BEFORE INDEPENDENT HEARING COMMISSIONERS APPOINTED BY THE  
TASMAN DISTRICT COUNCIL

Application for resource consent by  
**Māpua Community Boat Ramp Trust**

STATEMENT OF EVIDENCE OF GARY NOEL STEVENSON  
ENGINEERING

Dated: 1 November 2024

#2> boat trailer - lightning 20031125 1027 75°

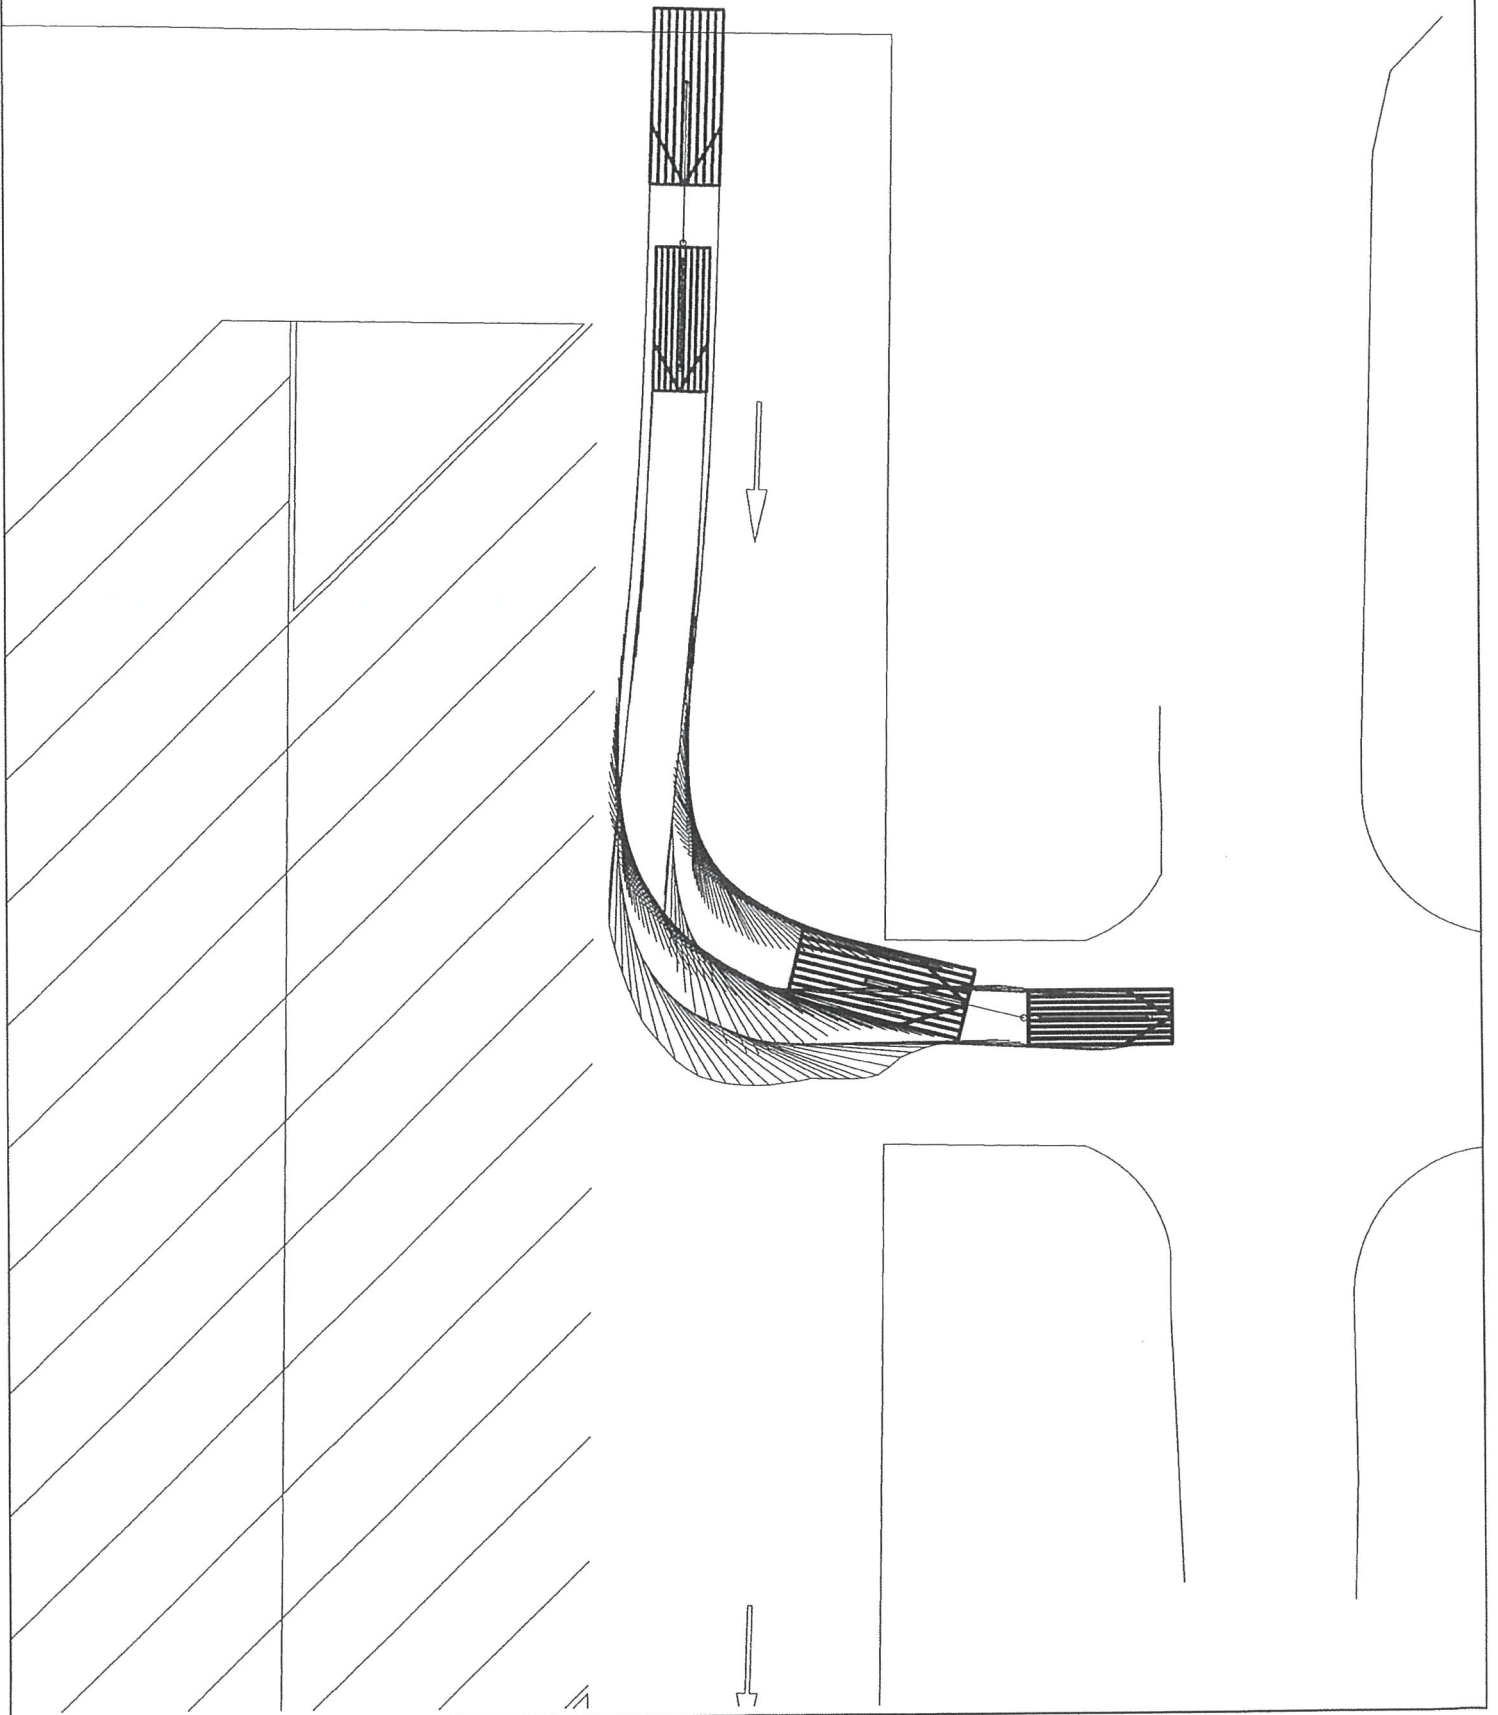
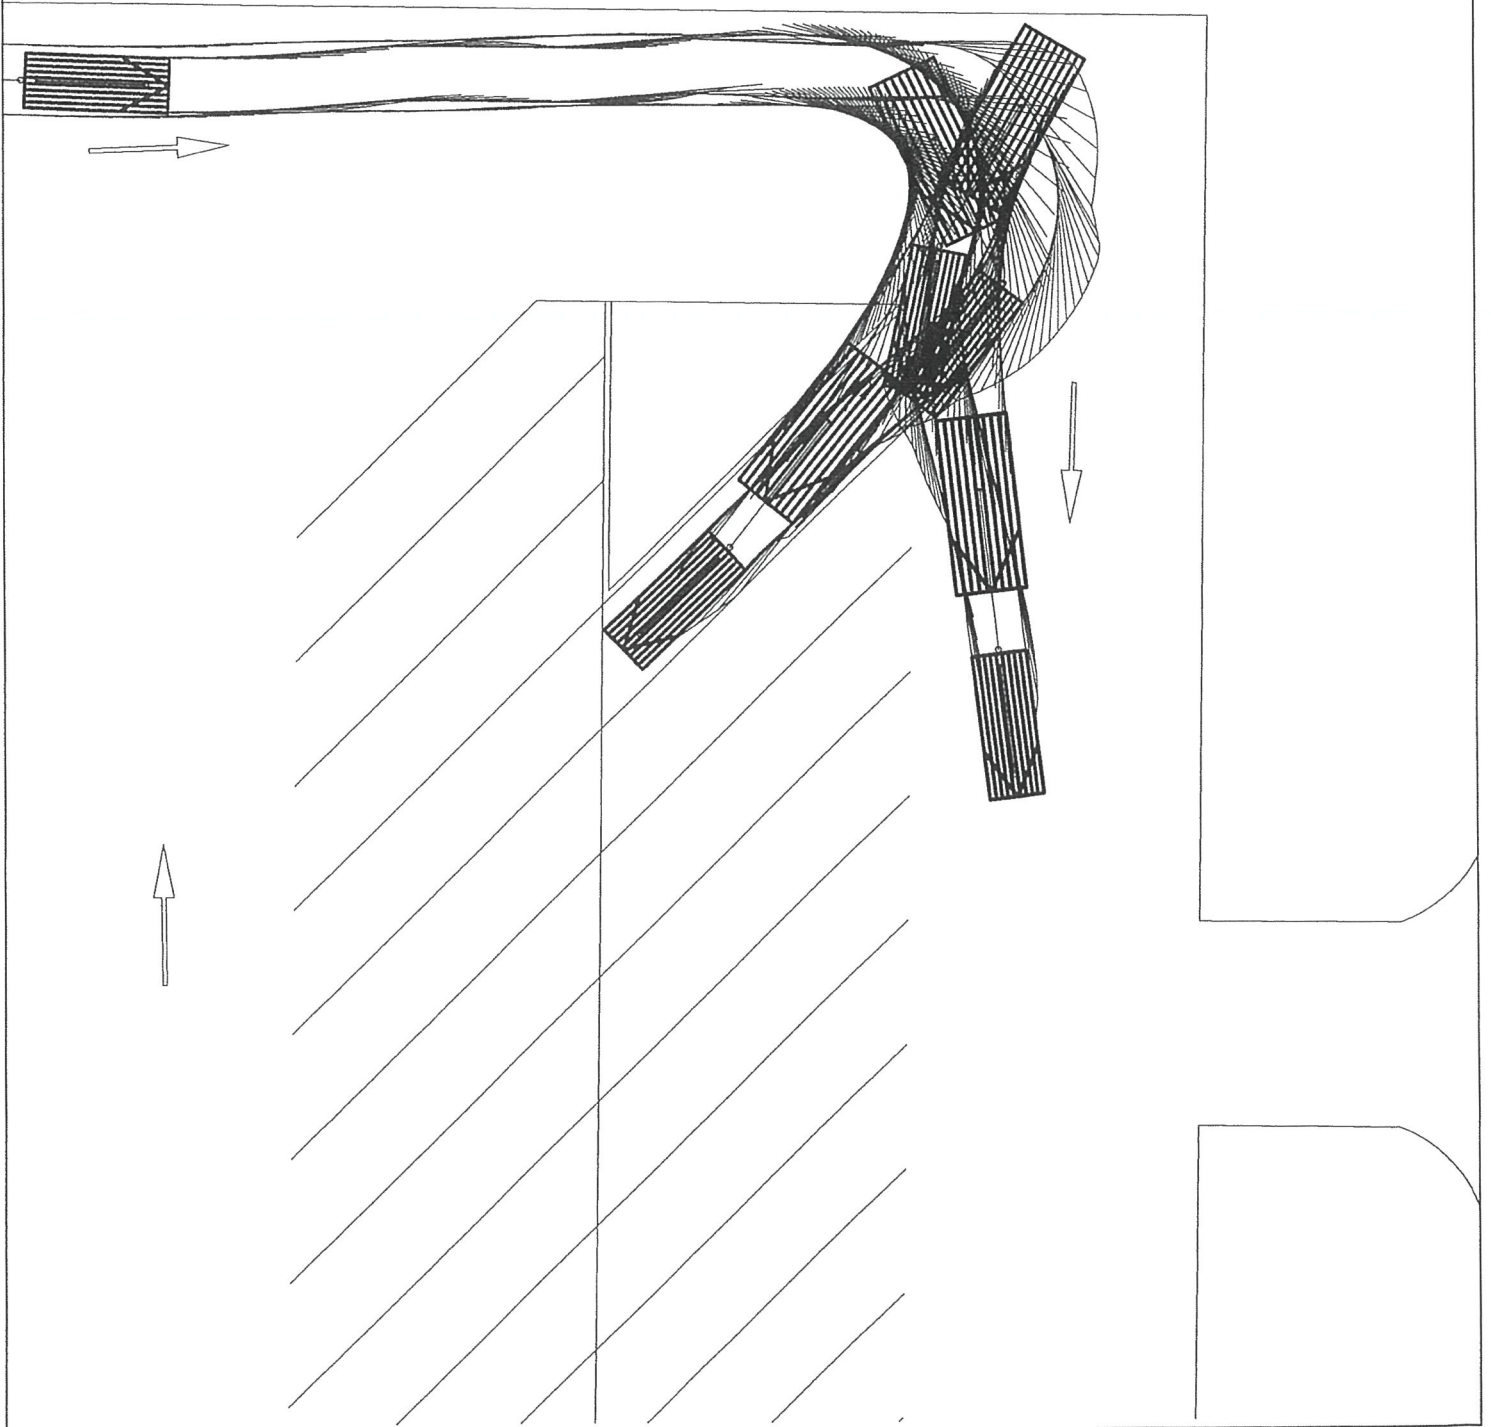
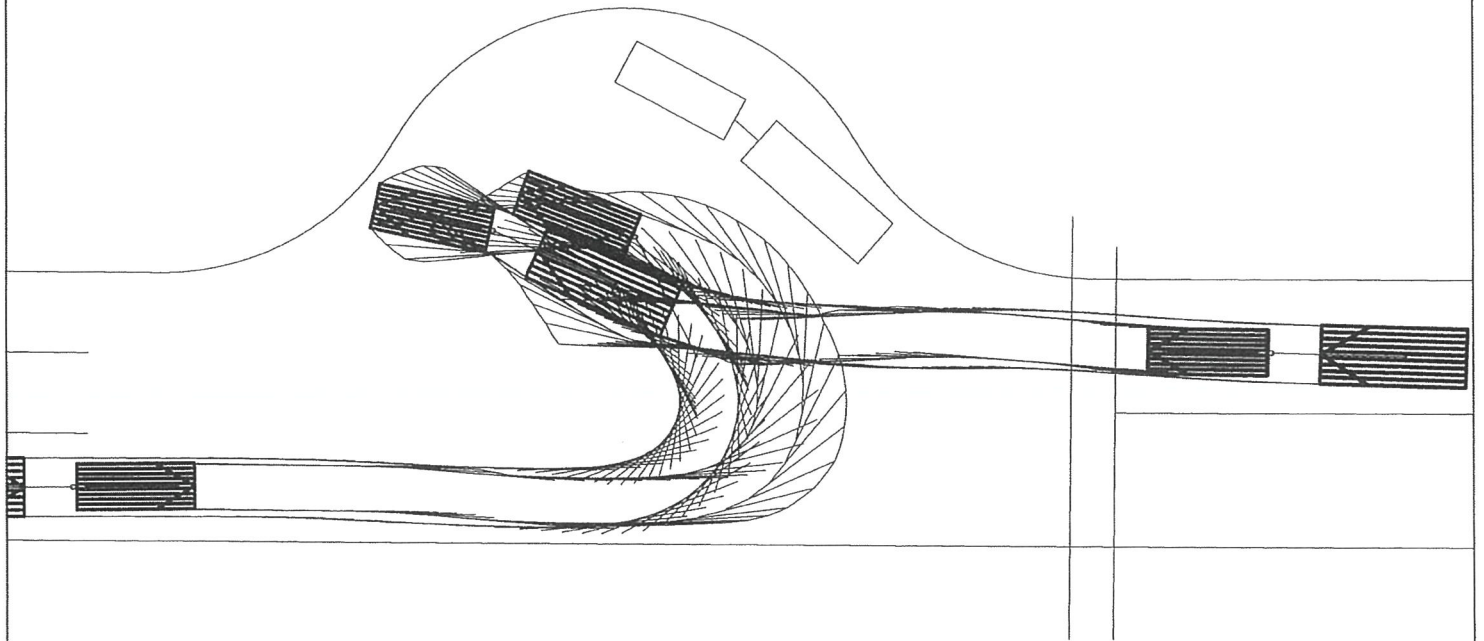
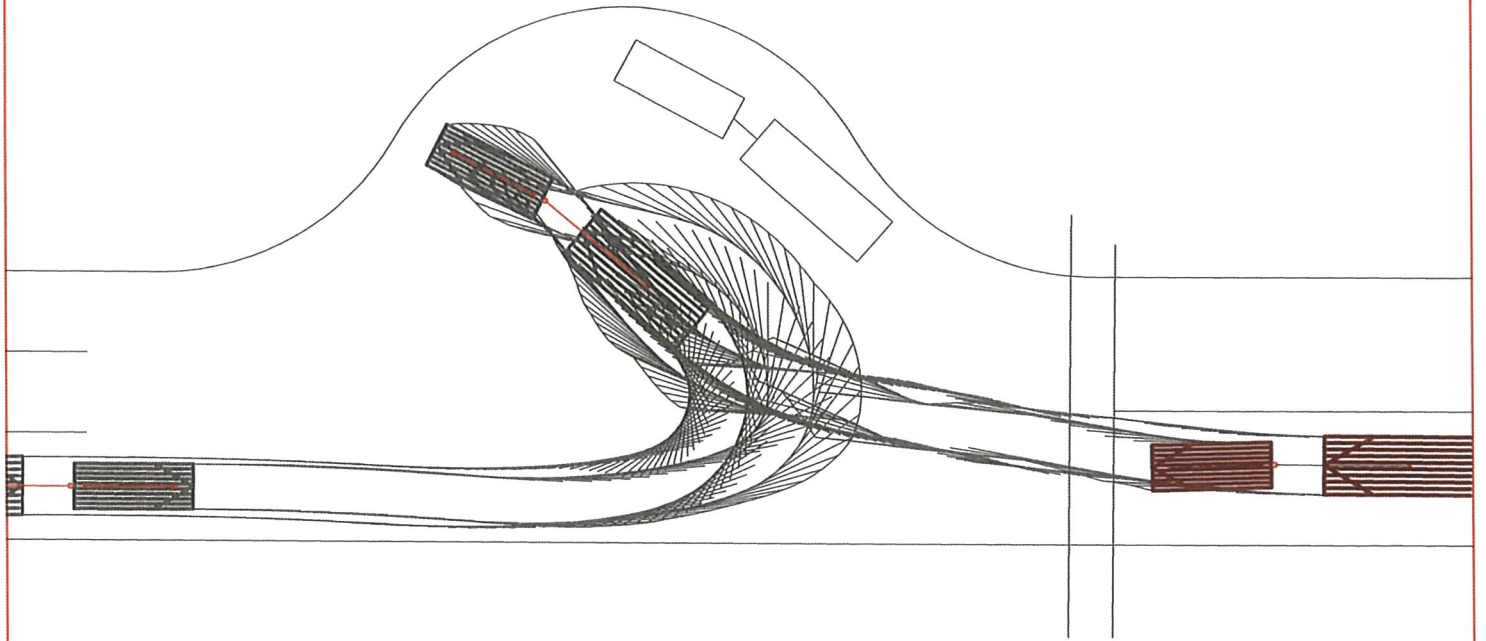
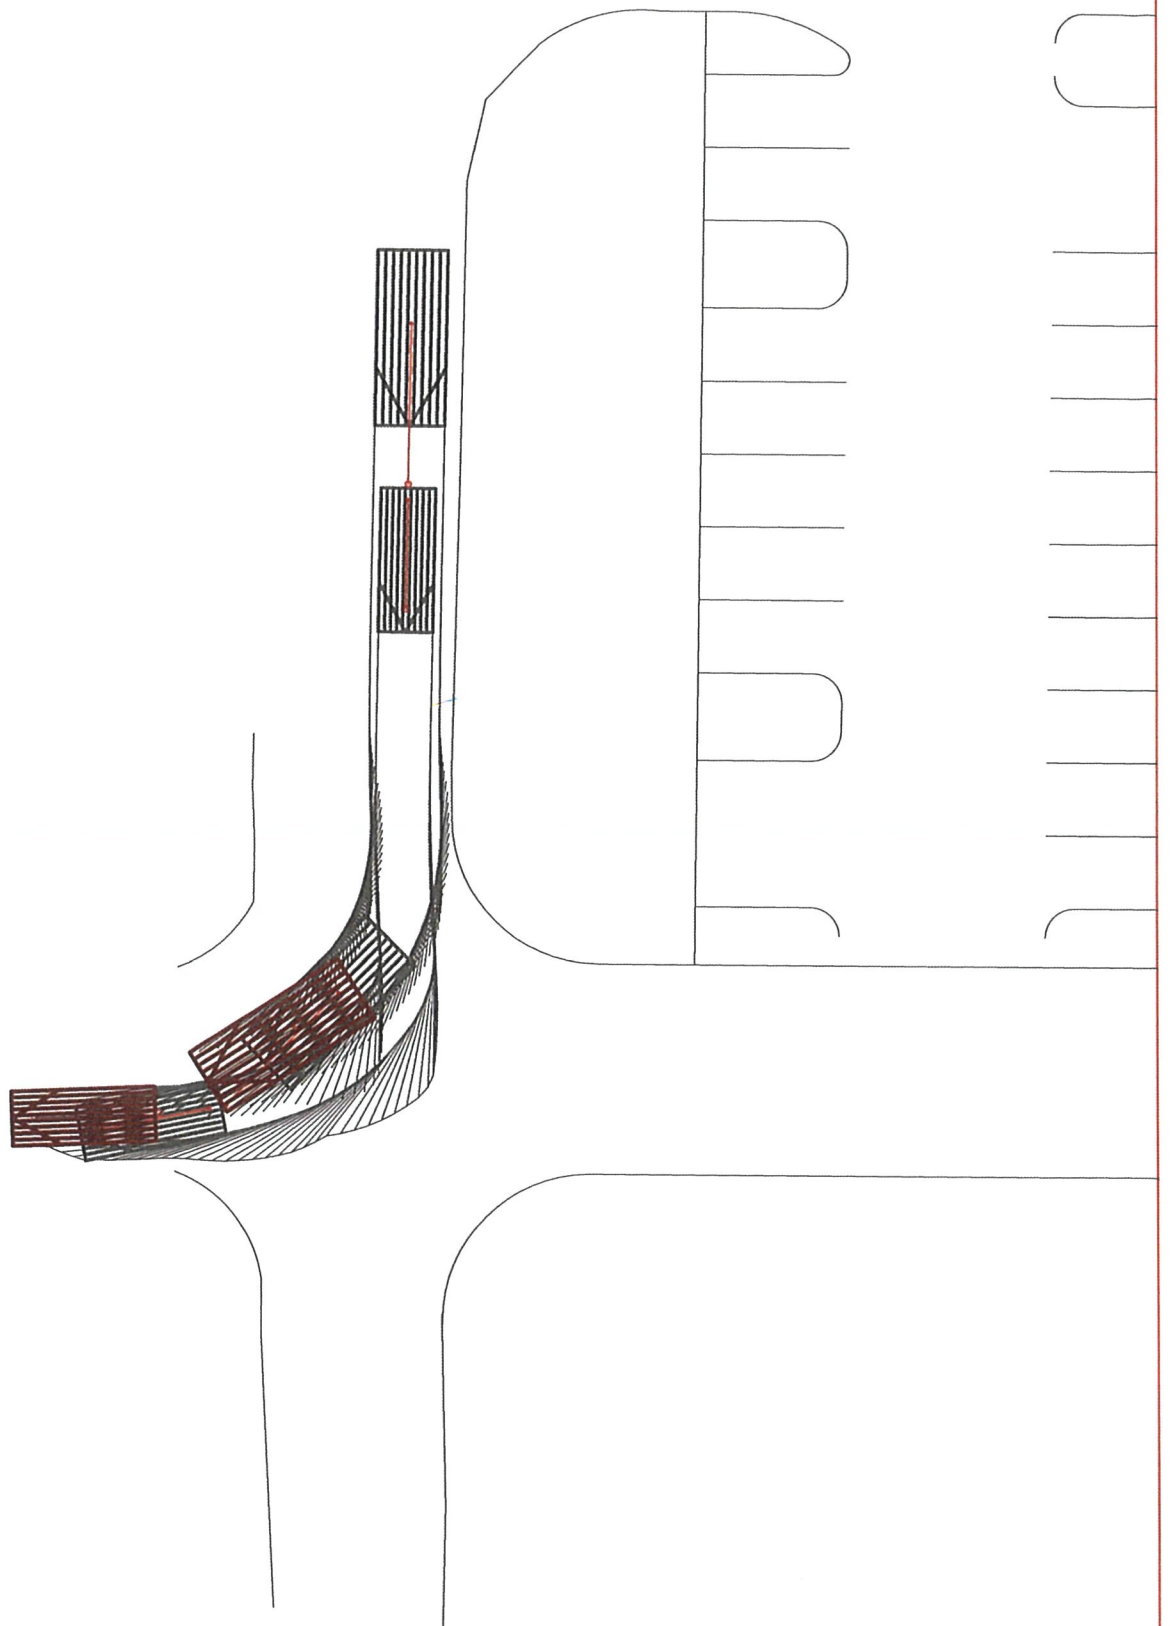
22. (S42, 14.11) Stantec raised concerns with swept paths of 10 parking spaces located in the western car park.

24. (s42, 14.23 & 14.24) Stantec have noted that tracking curves have not been provided for manoeuvring through the car park from the accessway barrier arm and on the ramp.

I comment: Annexed is a swept path analysis drawing that shows these parks can be utilised. I note that the parking is also provided for overflow parking and can be utilised for this purpose.

I comment: I annex tracking curves to show that this is achievable.
